Ref: 2018/6388/P
8575-Agar Grove Phase 2

Please find some clarification information to illustrate best endeavours have been carried out on phase 2 of the Agar Grove development in relation to condition 3 (f). The aim of our overview is to bring some context and clarification to the correspondence across various planning conditions that directly or indirectly have an impact on each other (3f, 25b, 41, 43).

CONDITION 3 (f)

3f) photovoltaics / solar thermal panels

Fig 1 and 2 showing the lightweight Bauder Bio Solar roof support for PV panels

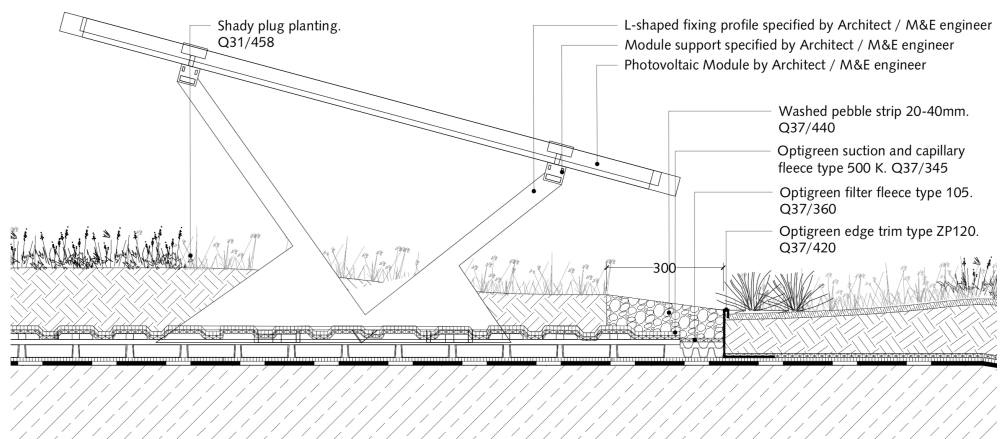
The original approved site roof plan showing living roof extents also showed PV panel array on this roof. Upon liaising with the industry, a 'through living roof solution' as suggested by the previous planning drawing is not possible on roofs with a pitch greater than 5 degrees.

This at the time of approval was a lightweight ballasted option like the Bauder Bio Solar roof installation support system which allows the living roof to continue growing under it and therefore the area of living roof is representative of that outlined at planning (i.e. full living roof). The light weight solution also minimizes / mitigates thermal bridging which is critical to reduce/eliminate where possible to achieve the Passivhaus Certification required as part of Condition 43.

Block H roof has a flat roof pitch of 11 degrees, so this system was never possible without significant detriment to living roof or significant risk added to Passivhaus compliance. This risk is concerning increased thermal bridging with heavy weight mechanical fixings through the roof to fix the PVs robustly on an 11-degree roof pitch which would increase fabric heat loss and be of

further detriment to overall Passivhaus SAP and area weighted average targets for the building (required as part of the solutions to achieve compliance for conditions 41 and 43). Please see email correspondence below as an appendix to this document.
